NEEDHAM PLANNING BOARD
Wednesday, September 7, 2022
7:00 p.m.

7:05 p.m. Major Project Site Plan Special Permit No. 2022-02: 557 Highland, LLC, an affiliate of The Bulfinch Companies, Inc., 116 Huntington Avenue, Suite 600, Boston, MA, Petitioner. (Property located at 557 Highland Avenue, Needham, Massachusetts). Regarding proposal to redevelop the Property with approximately 496,694 square feet of office, laboratory and research and development uses (see legal notice and application for more details). *Please note: this hearing has been continued from the June 7, 2022 and July 7, 2022 meetings of the Planning Board.*

Re: Highland Innovation Center – 557 Highland Avenue, Needham Heights, Massachusetts (the “Property”) – Application for Major Project Site Plan Review and Special Permits – Revisions dated as of September 7, 2022 Planning Board Public Hearing Letter #3

Title: OVERALL SITE PLAN

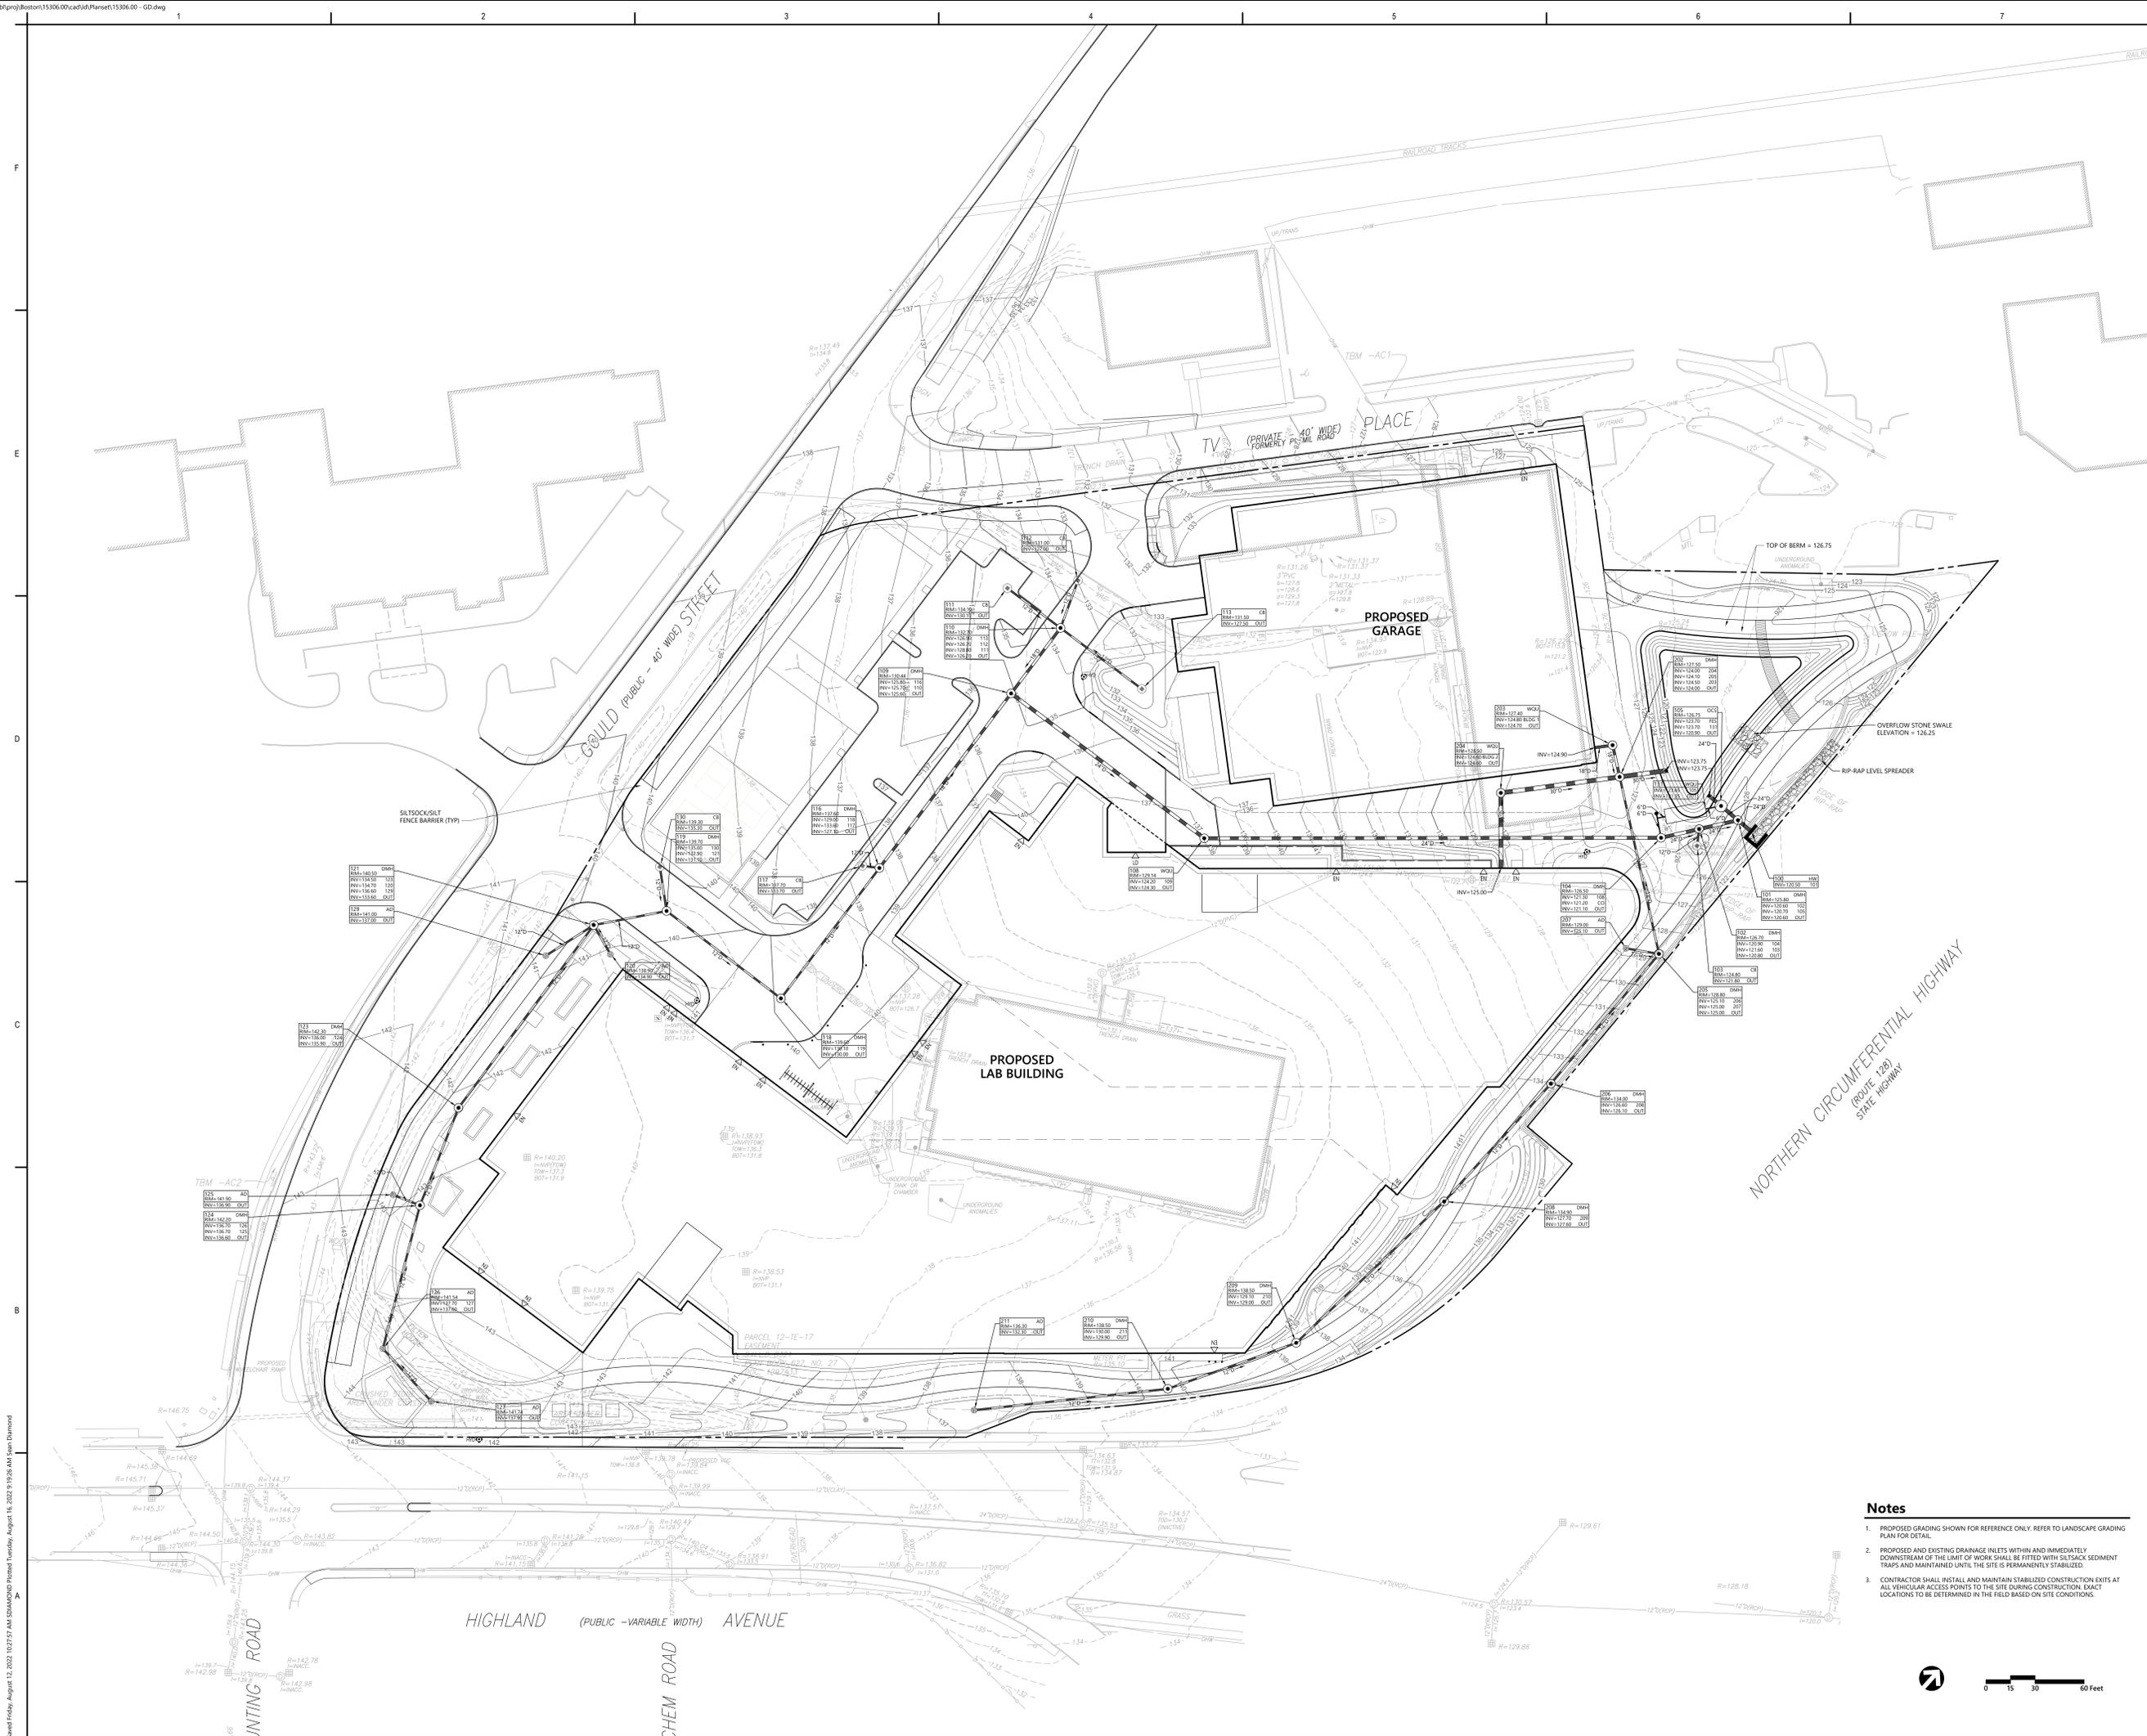
29. Figure 2 of the TIAS provides a site plan depicting the proposed layout and traffic circulation on the site. The plan appears to indicate that a loading/unloading area will be provided at the front of the site between Buildings A and B. This loading area is located in close proximity of the signalized intersection of the main site driveway and Gould Street. Vehicles, particularly trucks, stopped in this area could cause a back up of traffic into Gould Street. The Applicant should consider modifications to the site plan that provide a clear separation of loading/unloading areas and through traffic access to the parking fields to ensure traffic does not back up onto Gould Street. In addition, the Applicant should consider limiting hours of deliveries to the site, as a condition of approval, to avoid deliveries occurring between 7:00 AM and 9:00 AM when a high volume of traffic may be entering the site from Gould Street to access the parking garage.

31. The site plan included in Figure 2 does not depict any pedestrian connections between the proposed surface parking lot and the buildings. The Applicant should modify the site plan to provide fully accessible pedestrian routes between the surface parking lot and both buildings, as well as to the pedestrian loops around the site.

Client/Project: HIGHLAND INNOVATION CENTER
 Project No.: 218421343
 File Name: 218421343
 Scale: 1" = 30'-0"
 Title: GRADING PLAN
 Revision: Drawing No.

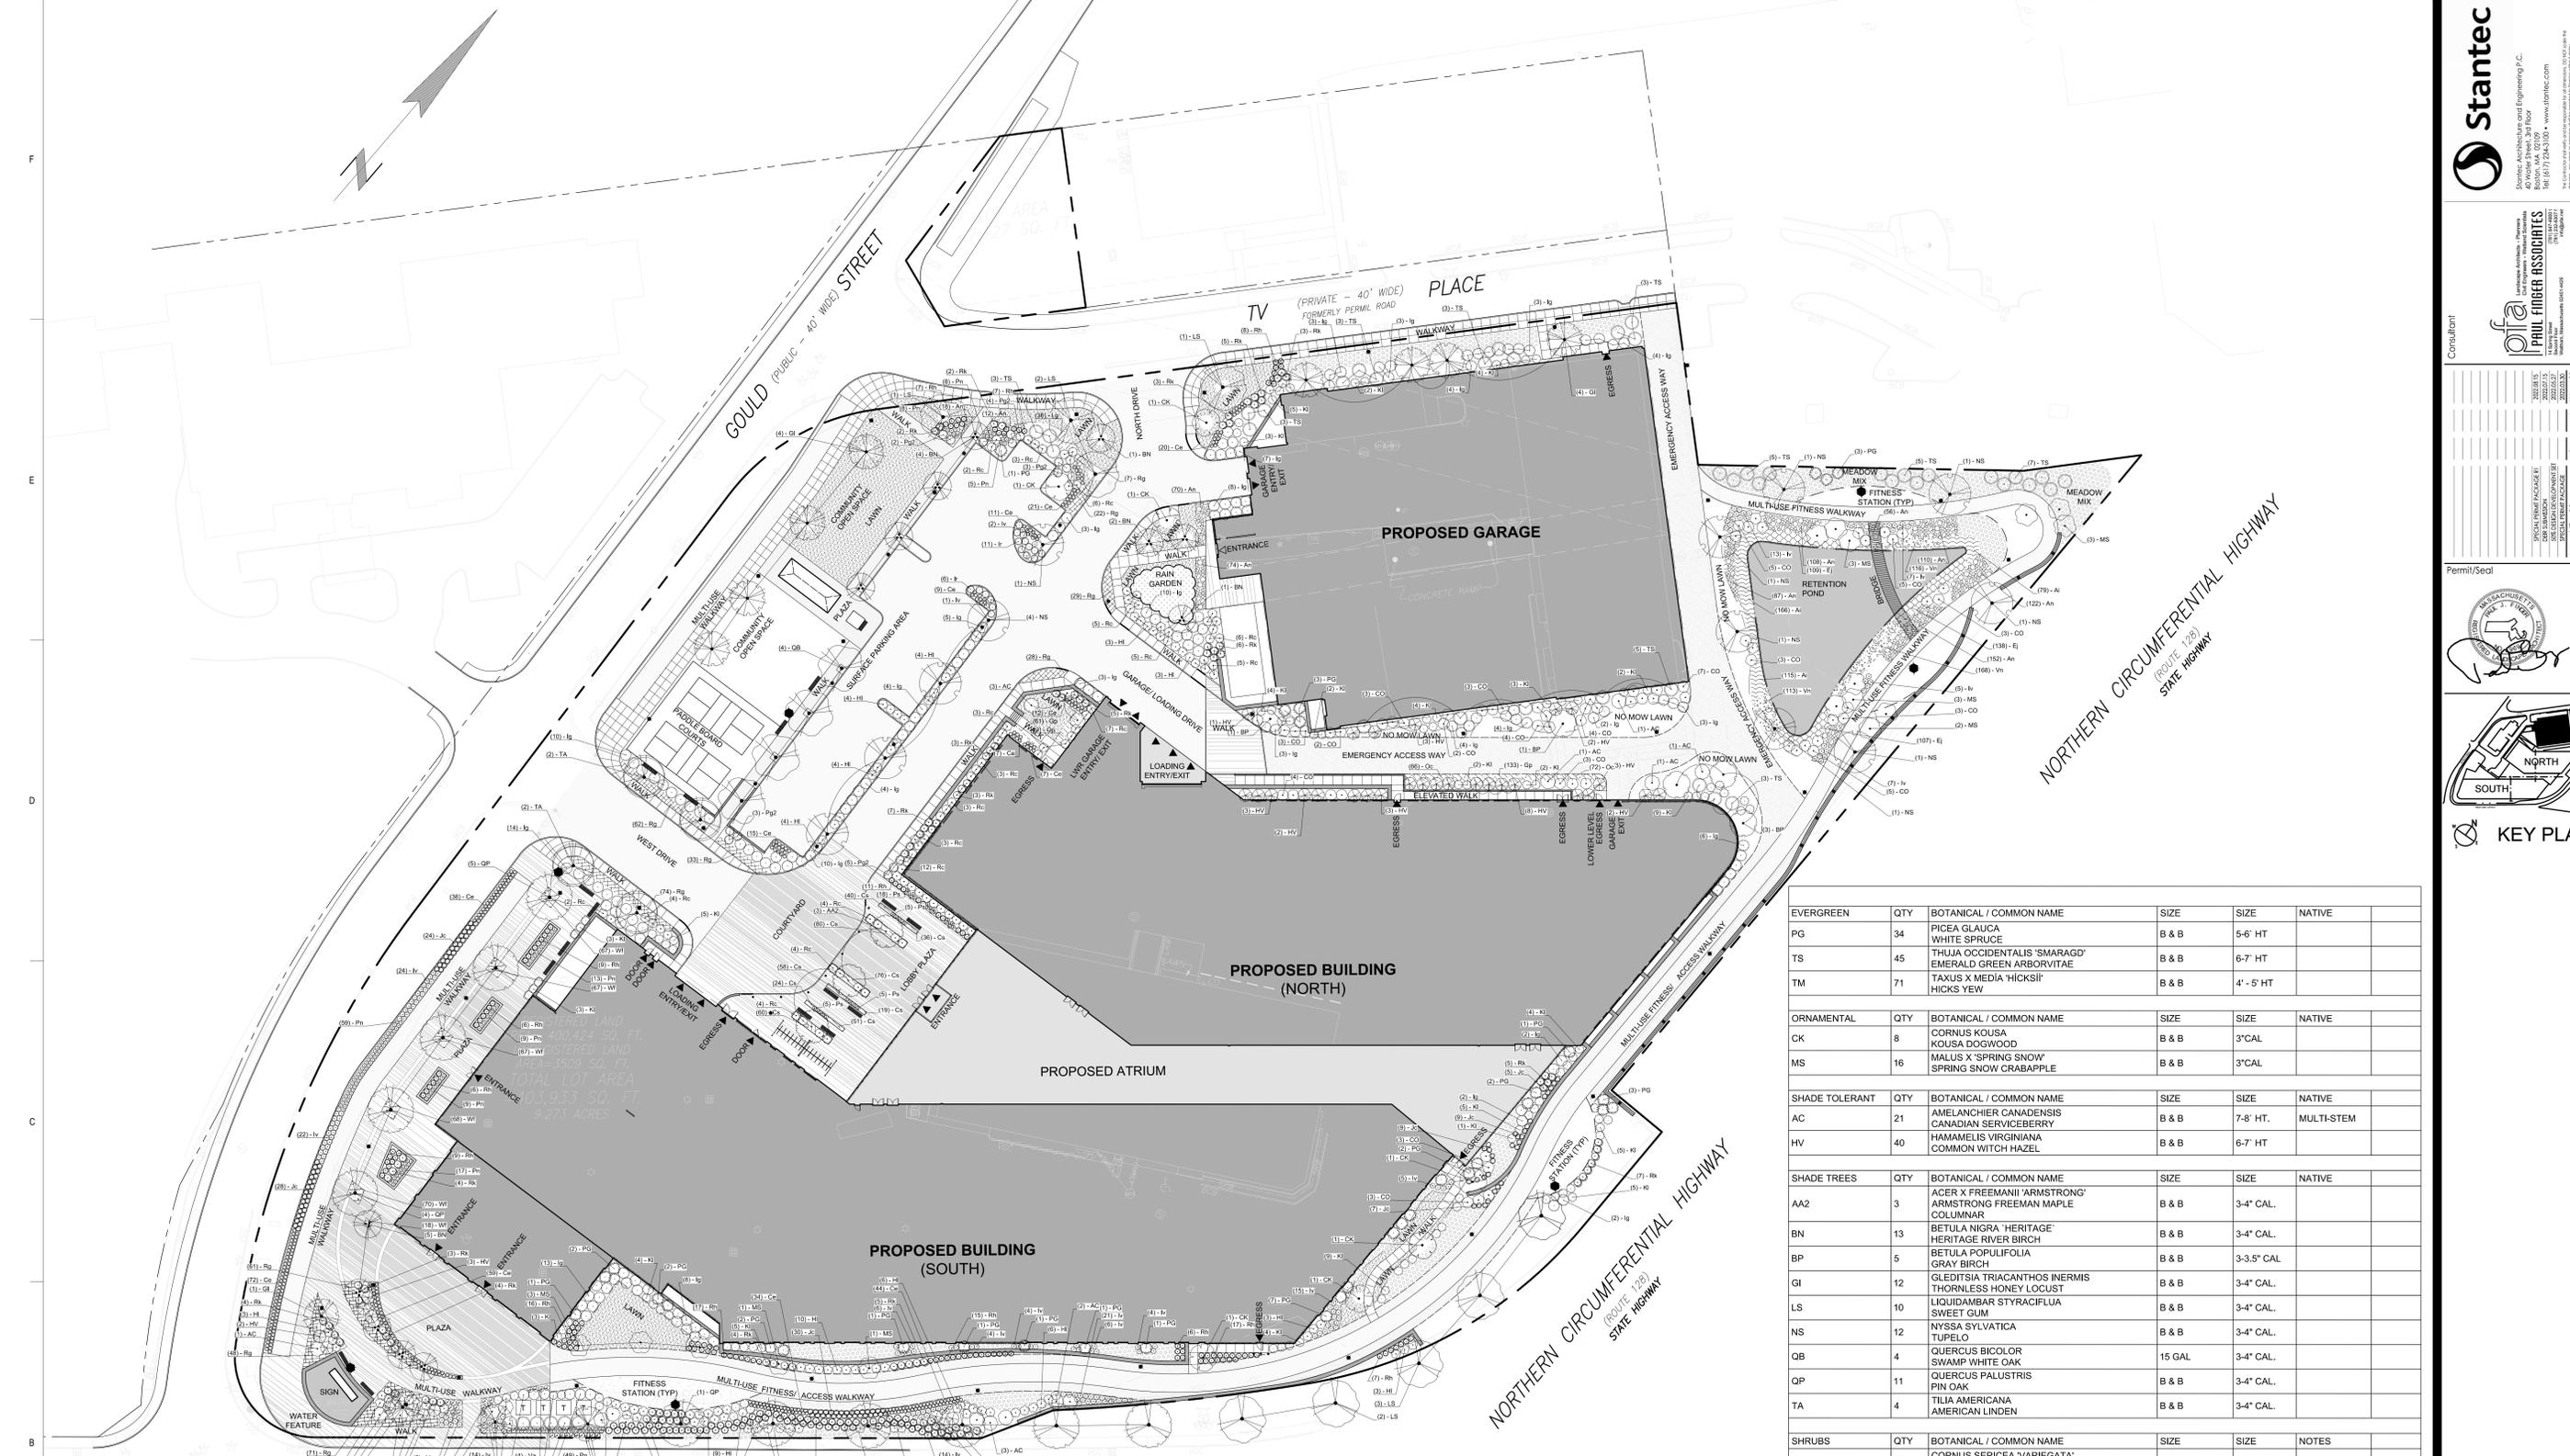
- **L-2.0 Grading Plan (see attached):**
 - Revisions associated with the additional site improvements as described above;
 - Raised elevations along building and garage perimeters to reduce visible building heights as much as possible;
 - Minimized slopes within Community Open Space areas along Gould Street in order to help facilitate the possibility of installing portable ice-skating rink.
